APPENDIX O2

Design Deviations

I-405, SR520 to SR522 Stage 1 (Kirkland Stage 1)

Draft RFP

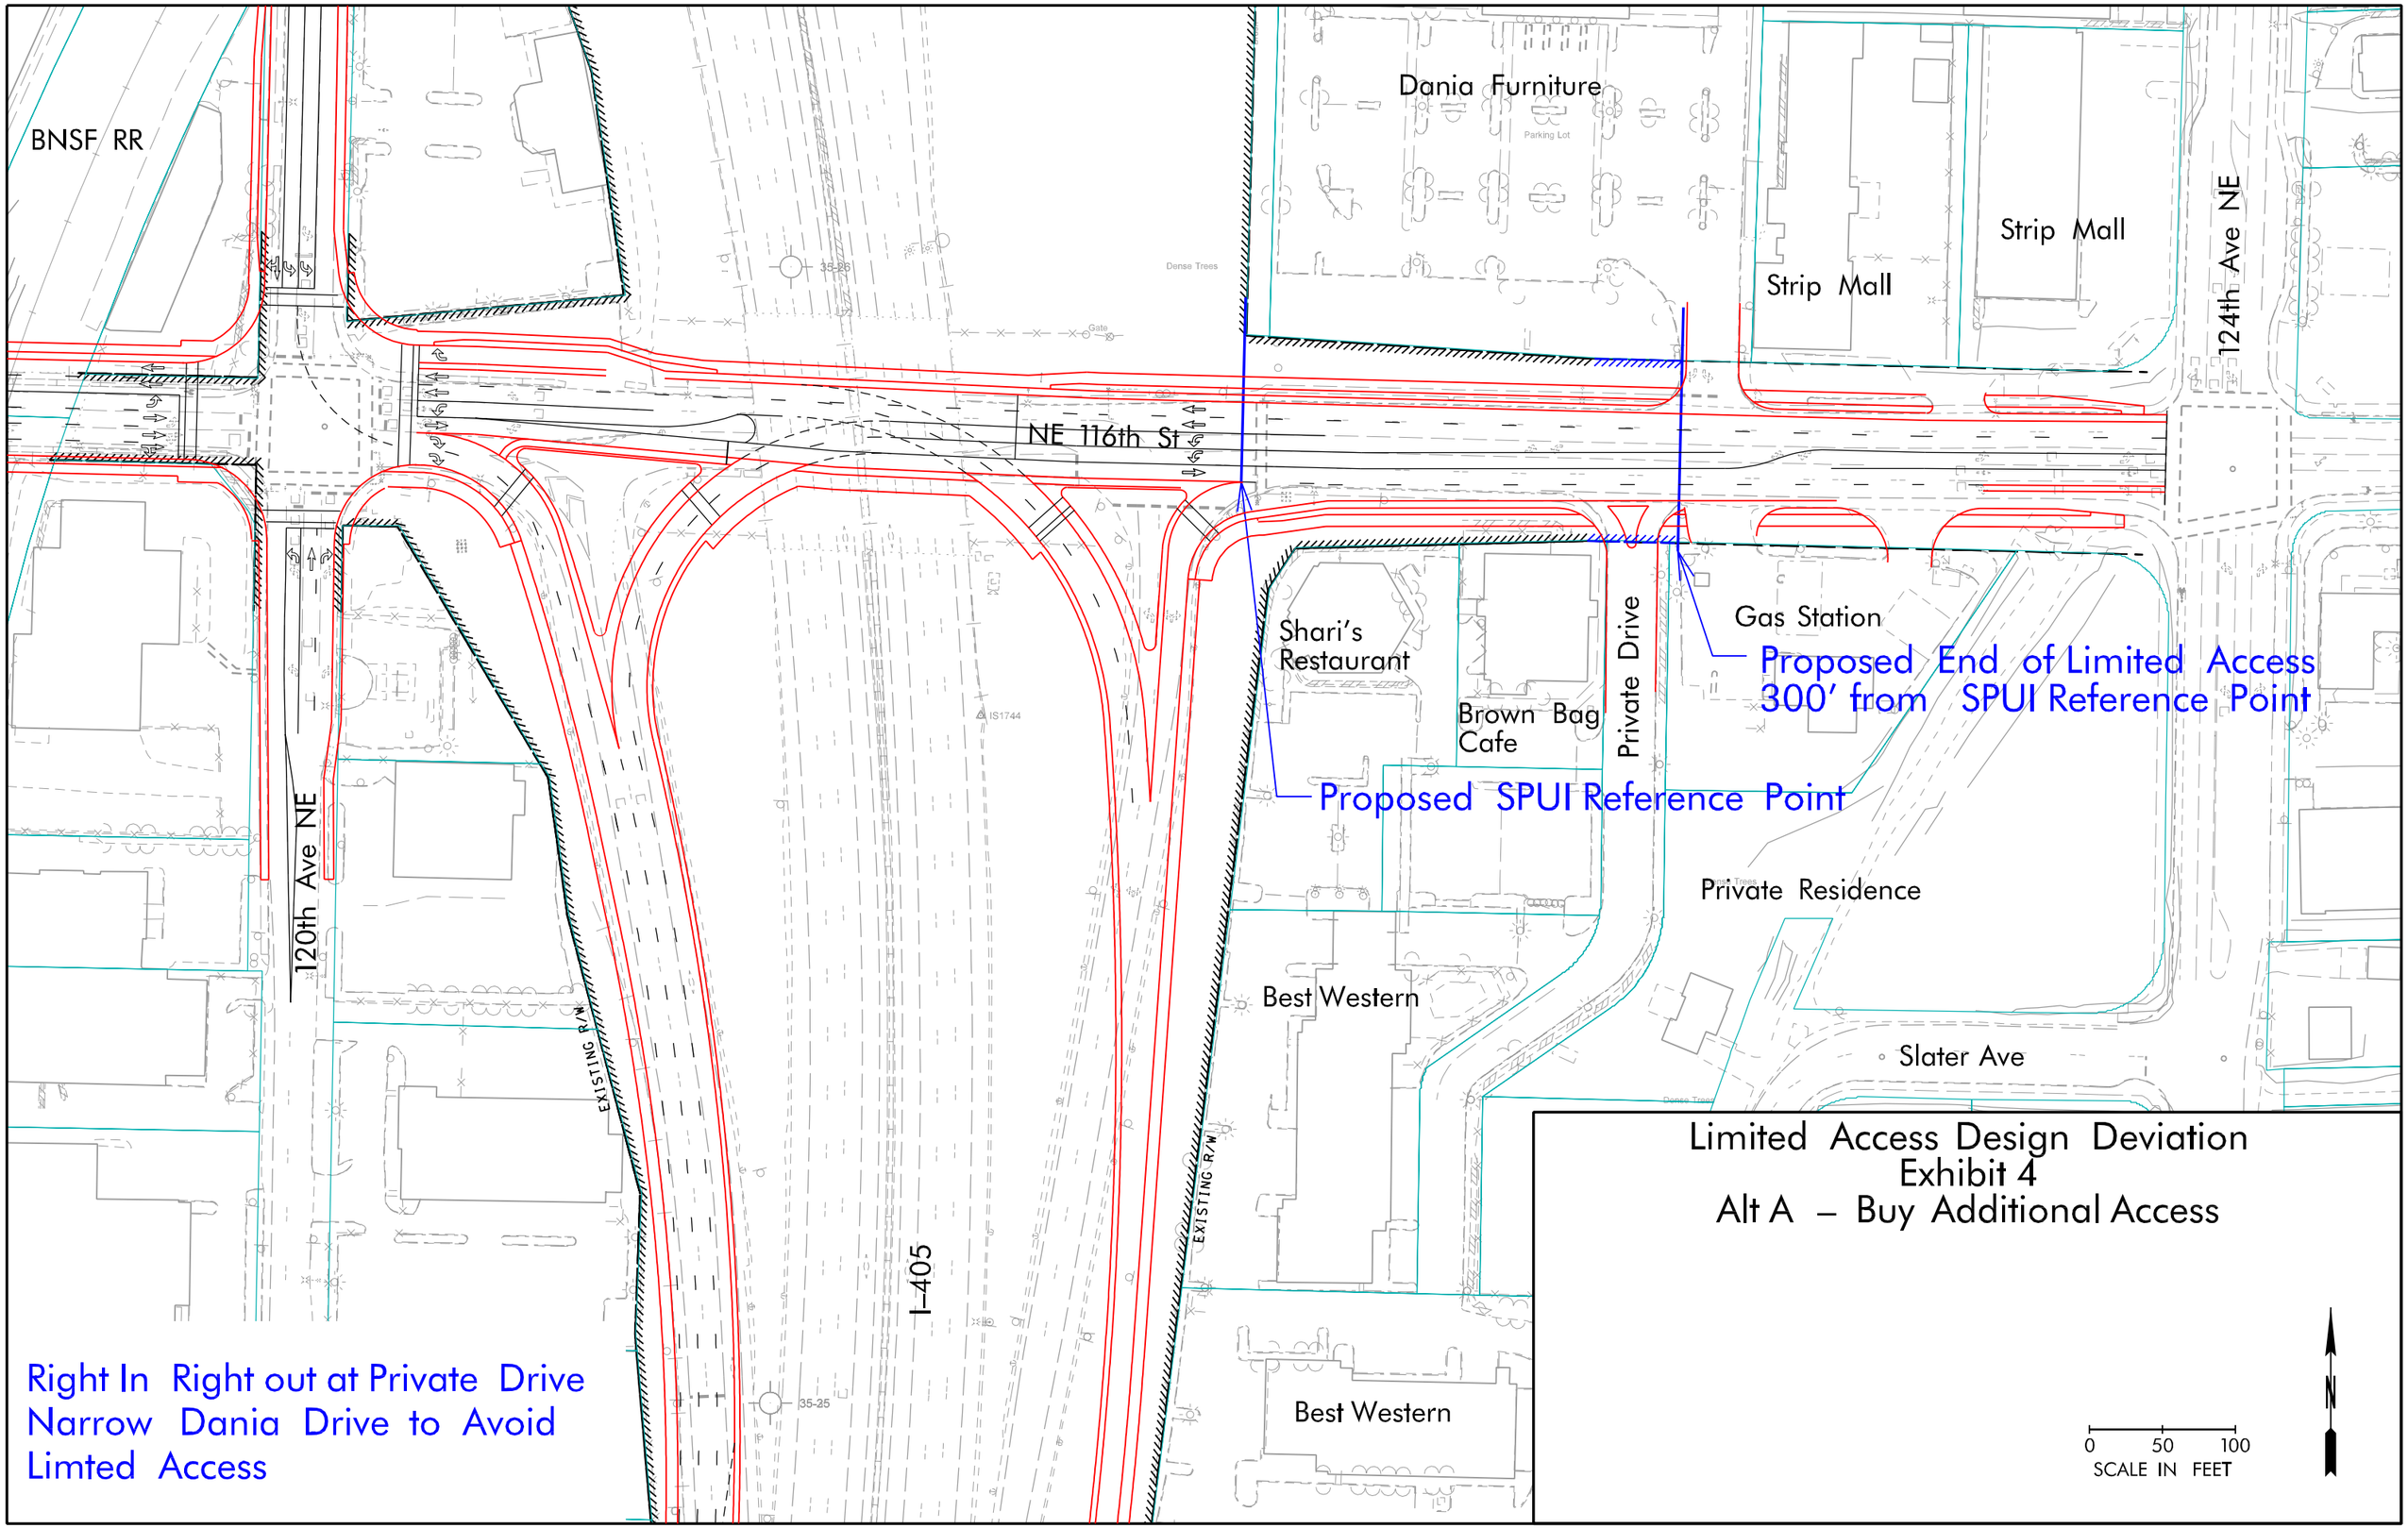
Alternative A Buy Additional Access Control (Exhibit 4) – Rebuild the existing half-diamond interchange as a half-SPUI, close the driveways west of the interchange and purchase approximately 65 feet of additional full access control east of the NB off ramp. Although the SPUI ramp terminal is only slightly east of the existing ramp terminal (Exhibit 3), the additional 65 feet is necessary because the reference point from which limited access is measured changes when turning movements are split by an island. The shared driveway and the driveway to Dania furniture would be affected by this option. However, Dania could rebuild their driveway, narrowing it by 5 feet, to avoid being constricted by WSDOT access control requirements. The western gas station driveway would be just beyond the new limited access boundary and therefore is out of WSDOT limited access control.

This alternative would benefit the community by helping to avoid conflicts near the interchange. However, this alternative would cost up to $20 million dollars to purchase out the 4 businesses. In addition the half-SPUI yield right to an add lane operates much the same as the existing half- diamond configuration does today.

Buying additional limited access (Alternative A, Exhibit 4) was not considered reasonable given that the accidents in this location don't warrant additional control and that the additional limited access would cost close to $20 million dollars if all 4 businesses along the private drive were purchased. The owners along this private drive were approached; however they are not interested in any voluntary changes. Therefore

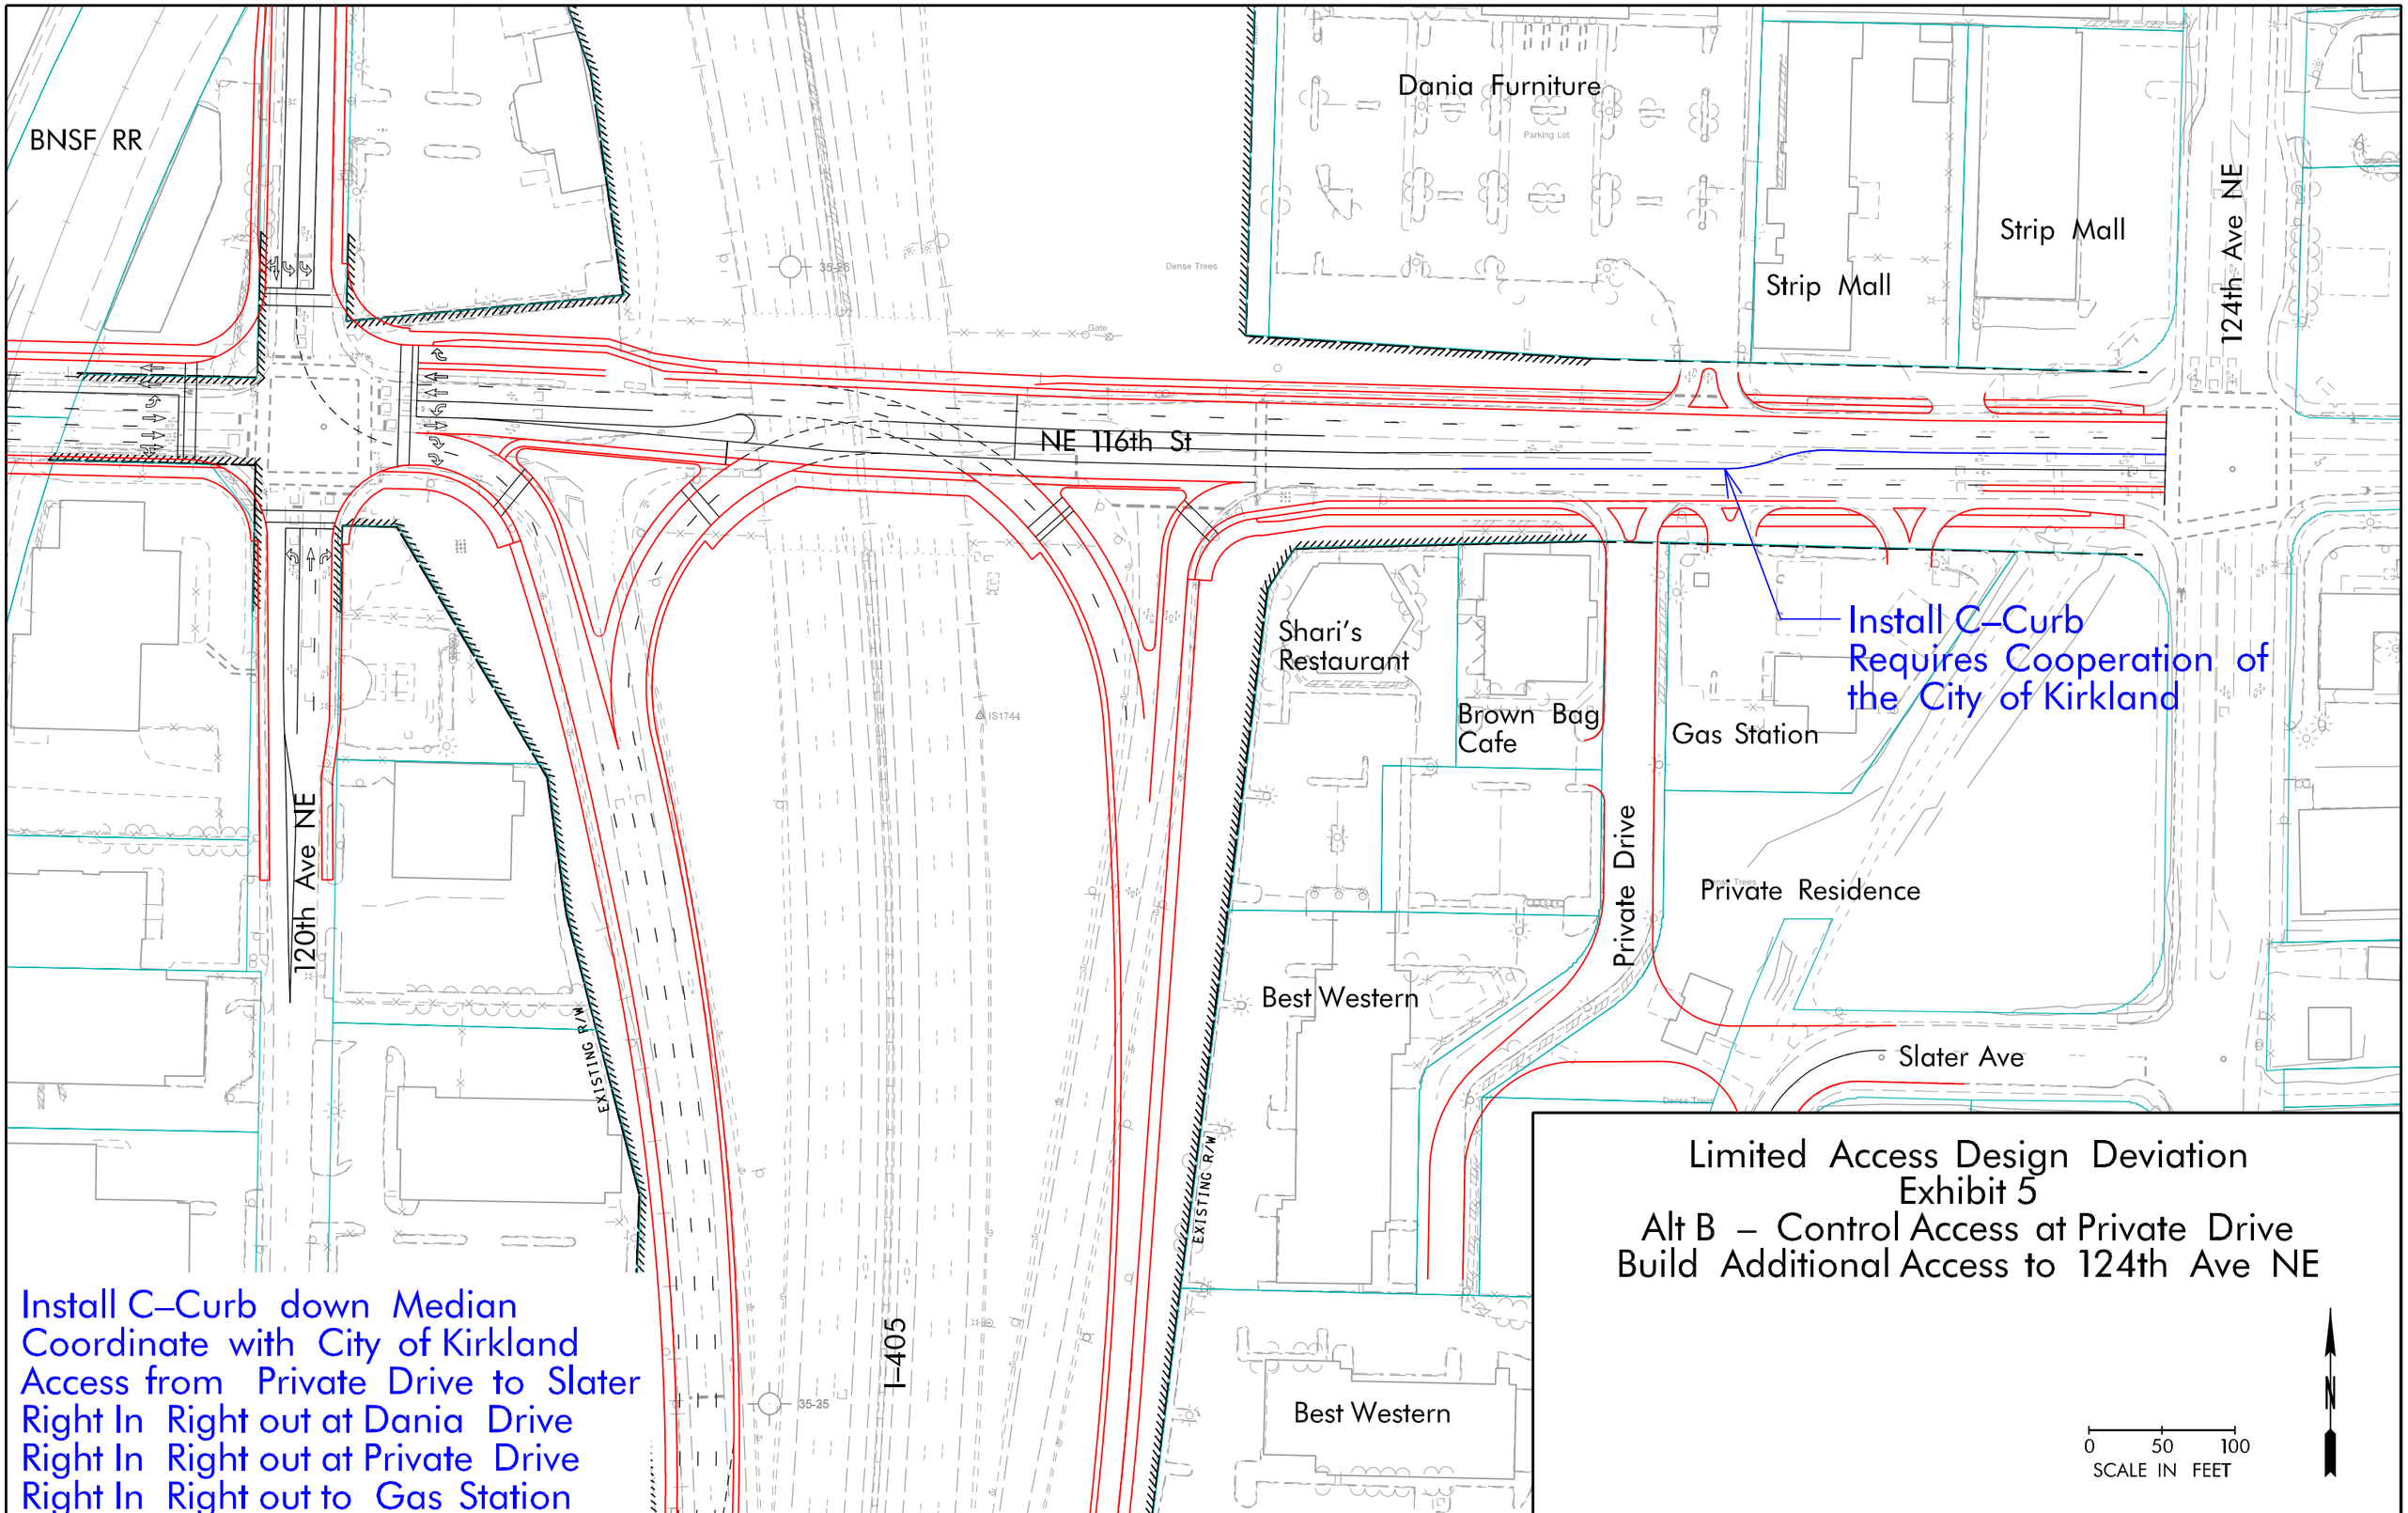
Alternative B Build an access from private driveway to 124th (Exhibit 5) – Manage access, without acquiring additional limited access, along NE 116th St. by building a new access from the back of the private driveway exiting onto Slater Avenue. This new connection would require purchasing additional ROW and may involve taking a church rectory. Current congestion on Slater Ave and 124th Ave NE may require additional mitigation due to the increased traffic. Right in – right out access to NE 116th St would be provided for the private driveway, both gas station driveways and Dania furniture, with all other traffic routed to 124th Ave NE. C-curb would be installed with cooperation from the City of Kirkland to enforce the right in right out access. An exit from the back

This alternative would give the businesses right in right out access to NE 116th St. causing some travelers a more circuitous route through a more congested 124th Ave. NE. In addition, creating an exit from the shared driveway onto Slater Avenue presents potential legal and traffic problems. Driveway access onto Slater Avenue would require a significant rebuild of the improvements the City of Kirkland will make as a part of the 124th Ave NE project. The intersection of Slater Ave and NE 124th St is not signalized. Vehicles making a left turn from Slater must cross two lanes of traffic and merge into an existing queue that extends several hundred feet south of Slater Ave. NE 124th Ave has high traffic volumes and severe congestion during peak hour. Even with the City's planned improvements, the congestion along this road will not be eliminated. This alternative would cost $1 million to purchase the land to build the alternative roadway.

Controlling access to the private drive (Alternative B, Exhibit 5) allowing only right in and right out and building an additional access for the private drive onto 124th Ave NE didn't seem to make sense from a traffic standpoint. Traffic along 124th Avenue NE is much more congested than NE 116th Street and without signal control at Slater Avenue making left movements would be difficult and problematic. In addition, this new roadway would tear out portions of what the City is currently building to improve this intersection. This alternative was approximately $1 million.
